GLEN EIRA CITY COUNCIL

Submission to the Activity Centres Program Stage 2

Map 3 - Caulfield Core Boundary and Building Heights

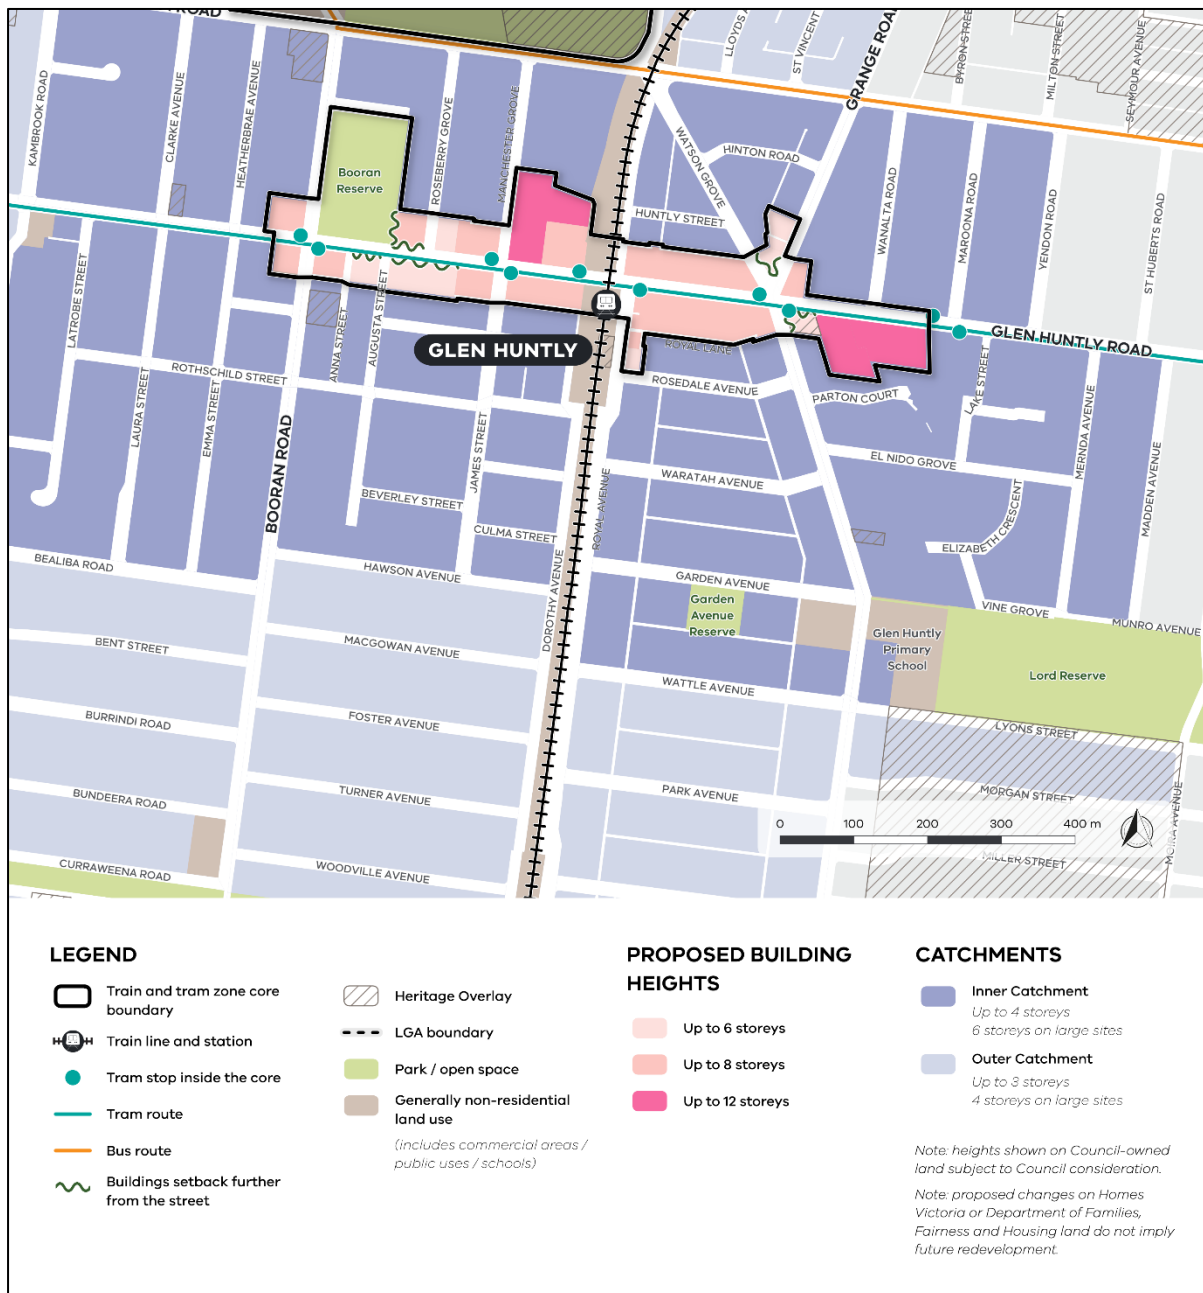
The boundary of the proposed core area is the same as the Caulfield Structure Plan which is supported.

The proposed heights follow a similar pattern though the Structure Plan recommendations were more responsive to local context. Rather than one height across a whole block, we had gradual heights which were based on urban design analysis, heritage and development feasibility considerations. Put simply, the heights got higher as you got further back from the street. We submit that this graduation should apply.

It is recommended that a maximum of 6 storeys is applied to the land along the section of Kambrook Road north of Station Street, Balaclava Road and Normanby Road. This would be more appropriate from a strategic perspective, given its residential context. Additionally, a zero-metre front setback in this setting would be inappropriate. A five-metre landscaped setback would be more suitable as per our Structure Plan.

At the southeastern edge of the activity centre, the triangular block between Dudley and Gibson Streets, north of the train line, is proposed to be 12 storeys rather than 9 storeys as per our Structure Plan. We are concerned with the visual and overshadowing impacts this would have on residential properties to the south and submit that 9 storeys is more appropriate.

We question why the property at 964-972 Dandenong Road & 4 Grange Road which is included in the core boundary, is shown as '*generally non residential land use*' on the Draft map with no building height applied. A current application under the State Government's Development Facilitation Program (DFP) proposes to rezone the land to the Commercial 1 Zone to accommodate a 10-storey mixed use application containing a large residential element.

The Strategic Development Site extending along Kambrook and Booran Roads is void of any building height guidance. This is extremely disappointing given that the adopted Structure Plan included building heights for this site which were informed by detailed built form and urban design analysis.

Map 7- Bentleigh Core Boundary and Building Heights

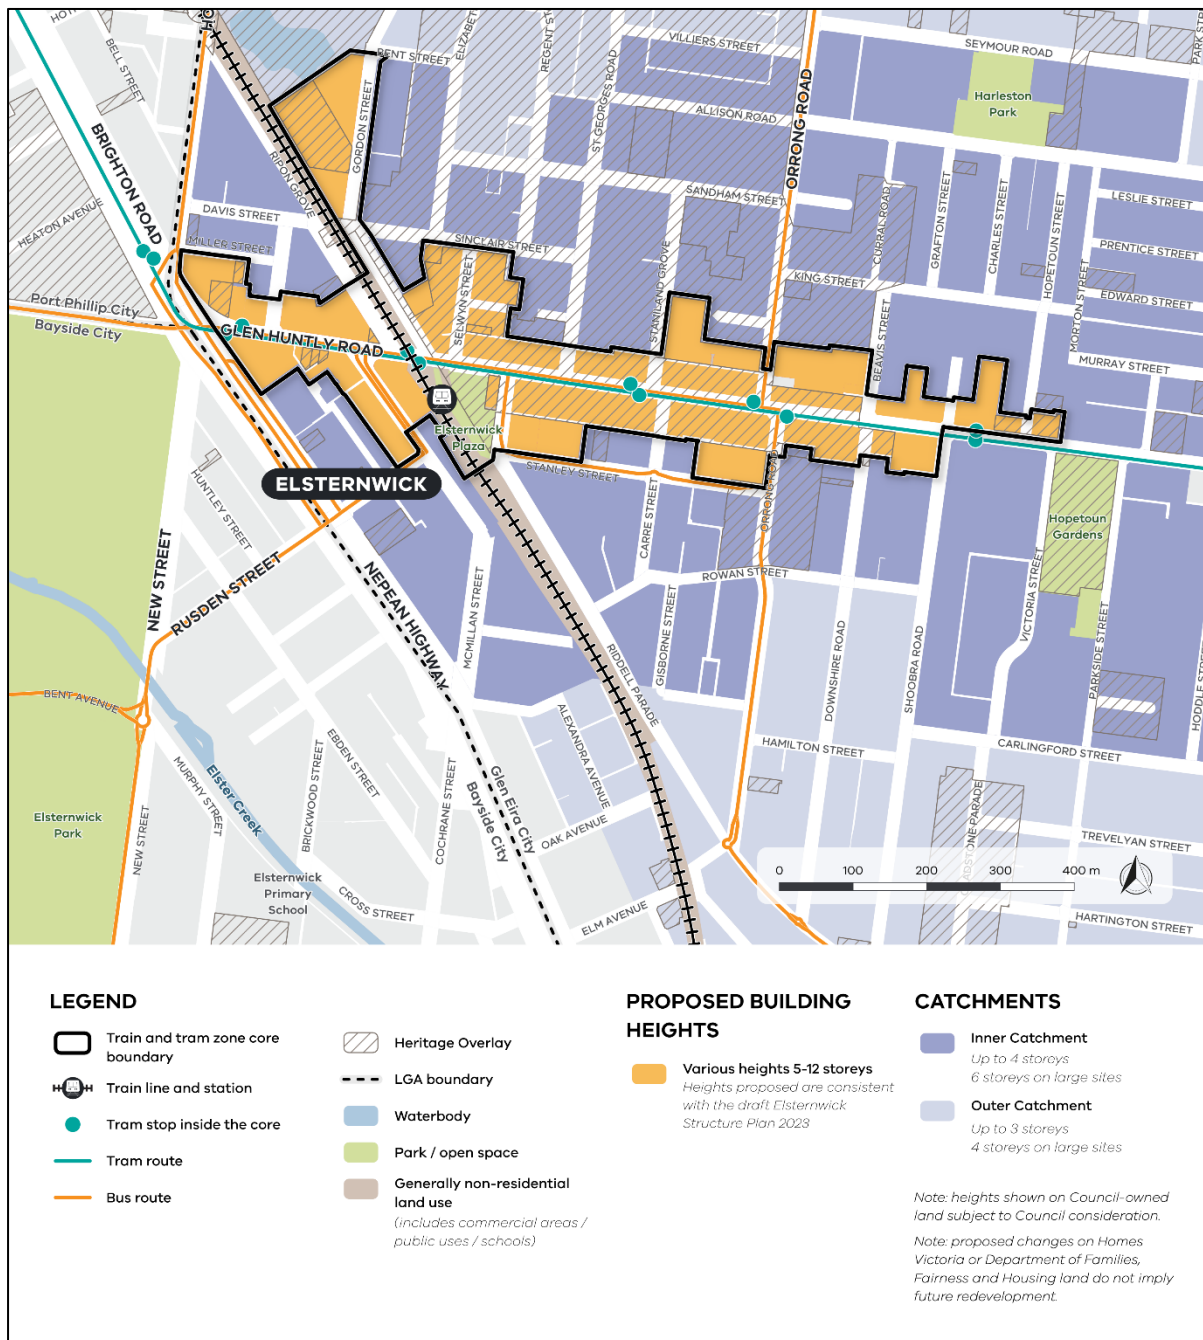
The proposed core boundary generally aligns with the Bentleigh Structure Plan except for some minor variations. The boundary should be extended further north of the Council car park between Vickery and Godfrey Streets to reflect the actual boundary of the car park.

Council generally supports the heights in the Bentleigh core and suggests that the 6 storeys on the north side of Centre Road could be increased to 8 storeys, subject to adequate building setbacks to manage overshadowing to the southern footpath. Additionally, the proposed heights to sites located north of public open spaces are supported subject to adequate overshadowing controls as proposed in our Structure Plan. This includes protection to Bentleigh Reserve (and the memorial cenotaph) and the Bentleigh Library Plaza.

It is noted that building heights have been proposed for most of Council's car parks that are in the Public Use Zone, Schedule 6 (PUZ6). This zone restricts most land uses unless they are for local government purposes. It is assumed that DTP proposes to rezone these sites to a Commercial 1 Zone to facilitate future housing growth. While a change in use could be considered in the future, as highlighted in our Structure Plan, Council needs to undertake further investigations before confirming future land use options. Rezoning these sites is not supported and could likely result in windfall gains tax implications for Council. We strongly object to the imposition of this financial burden without confirmed plans for the sites which could include community facilities.

Map 9 - Caulfield Catchments

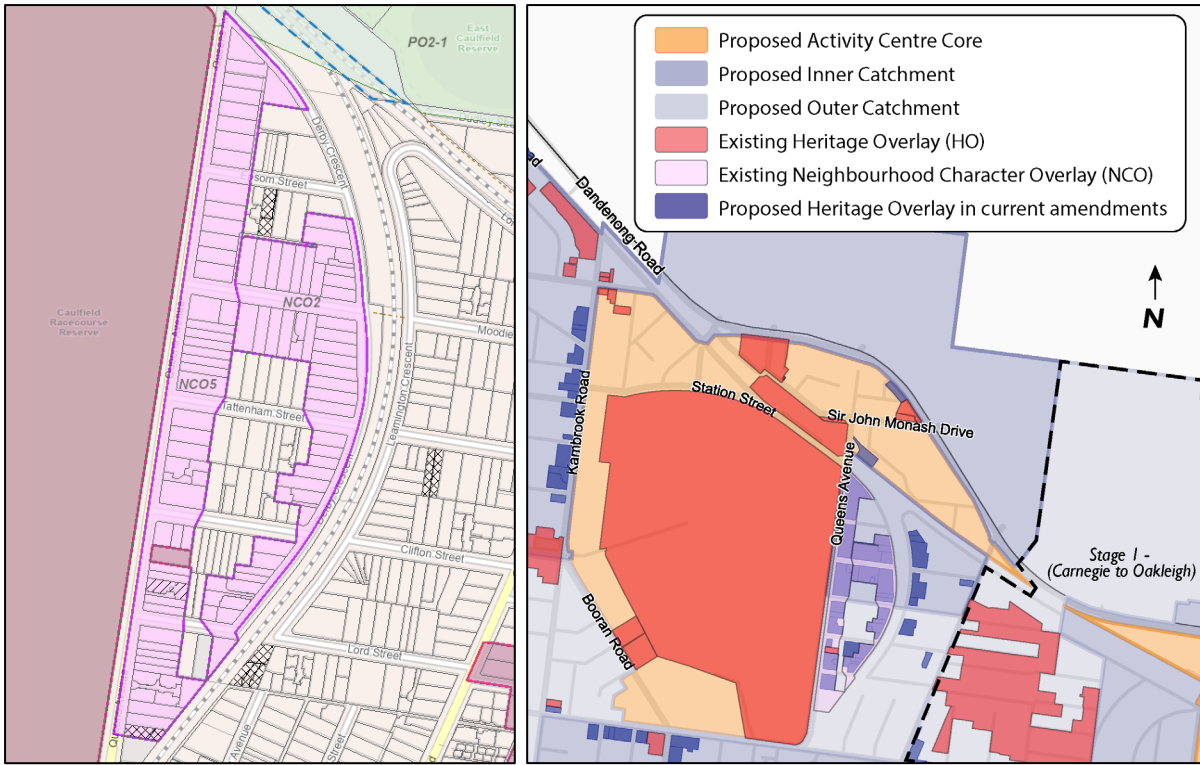
It is noted that this map is misleading, because the land to the east of Grange and Yendon Roads is also within a catchment from Stage 1 of the AC Program. This is a common issue with the draft maps and does not provide the community with a rounded and complete understanding of the changes they can expect to their immediate and broader neighbourhood.

The inner catchment for Caulfield is excessive in some areas. The block west of Bambra Road includes properties that are over 1.7 kilometres to the station. If it was chosen because this area is close to trams, local shops and Caulfield Park, why hasn't the same principle been applied to other areas, such as near Waverley Road within Stonnington? The application of the inner catchment also would result in an abrupt transition to a 2-storey zone, particularly along Eskdale Road. This area may be better suited to the outer catchment. The lack of information provided as part of the consultation material to support/explain the application of the catchment areas is considered poor. The inner catchment to the west of the centre should cease at Bambra Road.

The application of the catchments does not appear to account for significant physical barriers, such as poor pedestrian access via the rail underpasses (Smith Street and Queens Avenue), and the ten-lane Dandenong Road restricting access from the north. Other centres have applied these same accessibility principles to exclude land from catchments, and this inconsistency needs to be addressed.
